Intersection ID: 10033966		Main Street: PARK_RD		Cross Street: N/A		Location:		SW													
ADA ID: 7FDF46BDC5A0		Ramp Type: ParaDiag		Initial Pass/Fail: Fail		Overall Compliance: No		Severity Score: 26.25													
Codes/Mitigation Info/Possible Solution				Field Measurements/Component Compliance																	
		Possible Solutions:		Compliance		Description		Data		Compliance		Description		Data							
		Remove & Replace Curb Ramp With Two New Directional Ramps or Equivalent.		N/A		Ramp Length LT (in)		64.0		N/A		Ramp Length RT (in)		60.0							
				Yes		Ramp Width LT (in)		60.0		Yes		Ramp Width RT (in)		60.0							
				Yes		Ramp Slope LT (%)		2.9		No		Ramp Slope RT (%)		19.2							
				No		Ramp XSlope LT (%)		2.8		No		Ramp XSlope RT (%)		2.6							
				N/A		Landing Length (in)		N/A		N/A		DWS Provided?		N/A							
				N/A		Landing Width (in)		N/A		N/A		DWS Contrast?		N/A							
				N/A		Landing Slope (%)		N/A		N/A		DWS Length (in)		N/A

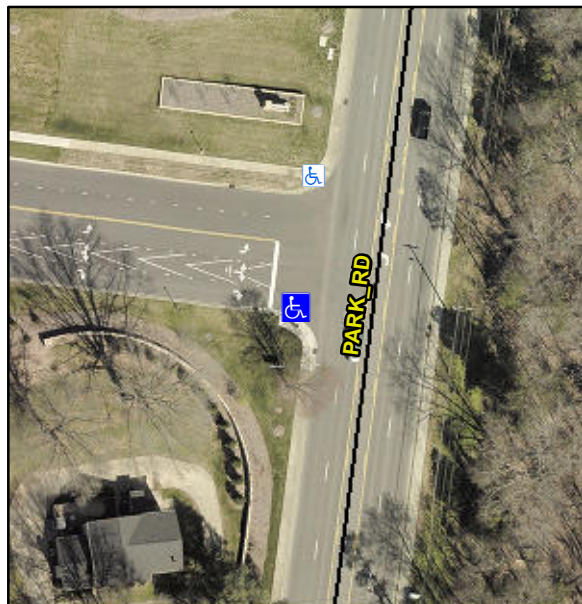
N/A		Landing X Slope (%)		N/A		N/A		DWS Full Width?		N/A							
				N/A		Landing Curb? (Y/N)		N/A		N/A		DWS Offset (in)		N/A							
<p>Surveyor Notes:</p> <p>LT RP < 5%</p> <p>PROW/ADA:</p> <p>R304.5.3, R304.3.2</p>				N/A		Shared Landing?		N/A				N/A		Gutter Slope (%)		N/A					
				N/A		Gutter Ponding?		N/A		N/A		Gutter X Slope (%)		N/A		N/A		Gutter Slope (%)		N/A	
				N/A		Gutter Lip Ht (in)		N/A		N/A		Gutter X Slope (%)		N/A		N/A		Gutter X Slope (%)		N/A	
				N/A		Painted X Walk1?		No		N/A		Painted X Walk2?		No		N/A		Painted X Walk2?		No	
						X Walk 1 Direction		To E				X Walk 2 Direction		To N				X Walk 2 Direction		To N	
				N/A		X Walk 1 Width (in)		N/A		N/A		X Walk 2 Width (in)		N/A				X Walk 2 Width (in)		N/A	
						X Walk 1 Slope (%)		4.6				X Walk 2 Slope (%)		4.9				X Walk 2 Slope (%)		4.9	
						X Walk 1 X Slope (%)		7.7				X Walk 2 X Slope (%)		5.5				X Walk 2 X Slope (%)		5.5	
				N/A		Ramp inside XWalk1?		N/A		N/A		Ramp inside XWalk2?		N/A				Ramp inside XWalk2?		N/A

Road Slope (%)		8.3		N/A		Clear Space?		N/A				Clear Space?		N/A	
<p>Total Cost:</p> <p>\$ 3200.00</p>						Road X Slope (%)		1.2		N/A		Clear Space to XWalk (in)		N/A				Clear Space to XWalk (in)		N/A	
				N/A		Any Obstructions?		N/A		N/A		Storm Grate/Utility Hazard?		N/A				Storm Grate/Utility Hazard?		N/A	
						Obstruction Type						Storm Grate/Utility Type						Storm Grate/Utility Type			
								N/A						N/A						N/A	
										Yes		Surface Condition? (G/P)		Good				Surface Condition? (G/P)		Good	
										N/A		Curb Slope (%)		10.1				Curb Slope (%)		10.1
